Quality Control Check Report. Stage: Before Casting Plinth Beam (Villas)

Block No	57	--	SI. No.	31481
Company	Sov (I/P)	Project	Phase	IX
Prepared by	V. Sanketh	Sign	Date	15-09-18
Project Manager	Purshottam	Sign	Date	15-09-18
Previous stage report no.	30073		Report filed and signed by PM?	<input checked="" type="checkbox"/> Yes <input type="checkbox"/> No
Checked By MD on	MD Sign		For filling	<input type="checkbox"/> Yes <input type="checkbox"/> No

Description	Direction	Owners & Developers :	Date :	Promoted by
QUALITY CONTROL PLINTH BEAM CHECK PLAN TYPE-A1 (3BHK)	N	Silver Oak Realty Project Name & Phase : Silver Oak Villas	15.11.2017 Prepared By : Nagalaxmi Approved By : Soham Modi Scale : N.T.S	Modi Properties & Investments Pvt. Ltd. Phone:+91-40-6633555

ATR on Quality Control Check Repot. ^{Villas} ~~(Residences)~~

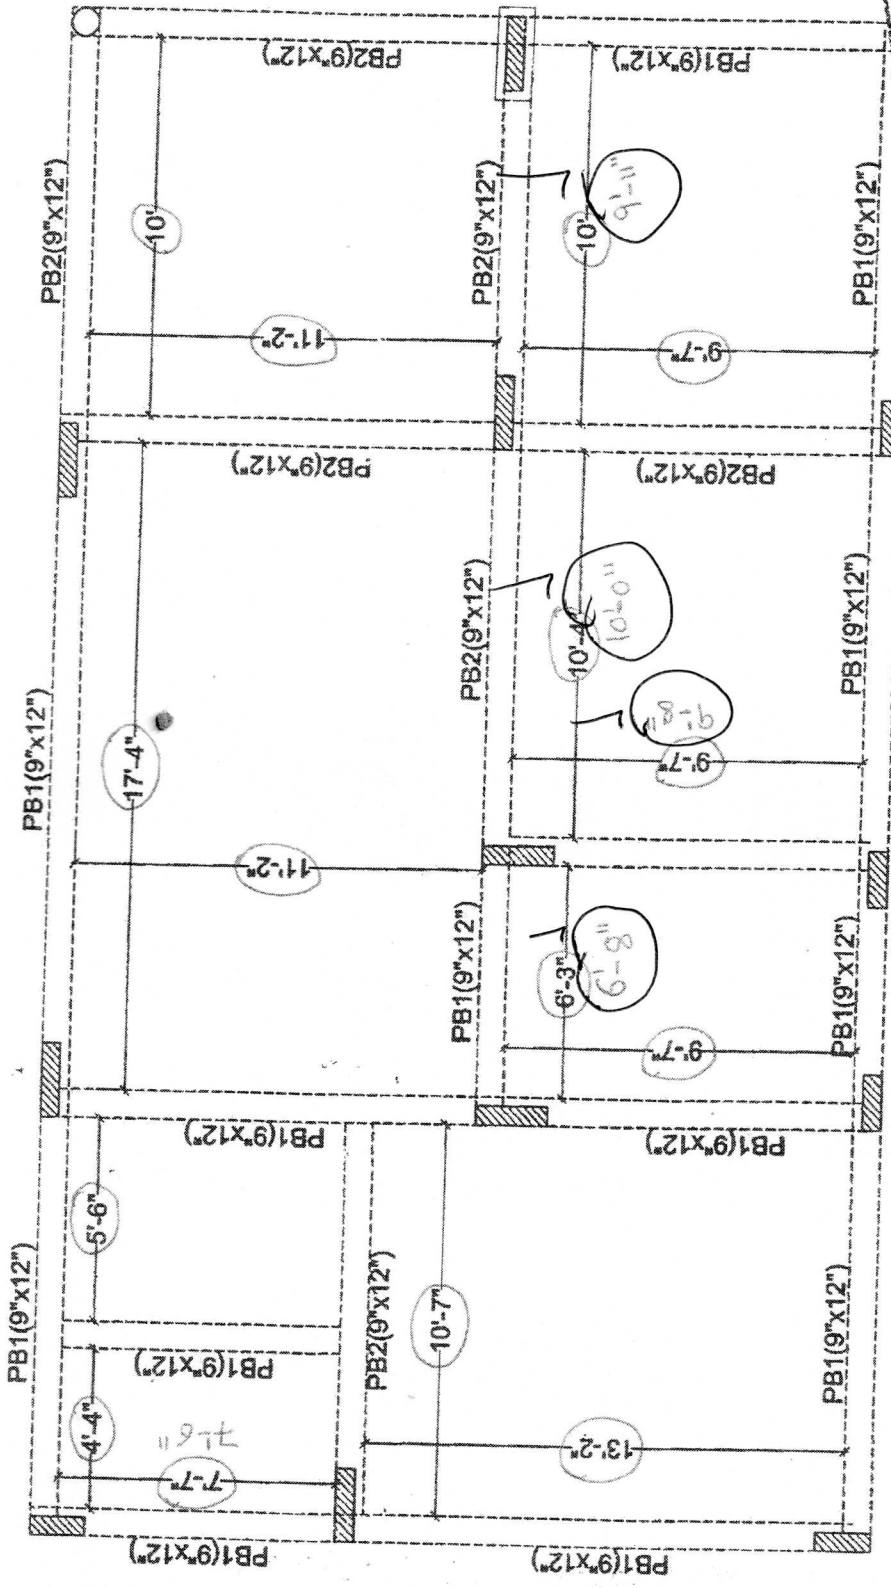
Column steel overlapping and cranking? (overlapping length should be 45 to 50 D)	<input checked="" type="checkbox"/> Correct <input type="checkbox"/> Needs correction
Pedestal/column - self check report attached?	<input checked="" type="checkbox"/> Yes <input type="checkbox"/> No
Remarks:	<u>(Note) Mud not levelled properly inside of villa.</u>

Remarks: All works are Completed
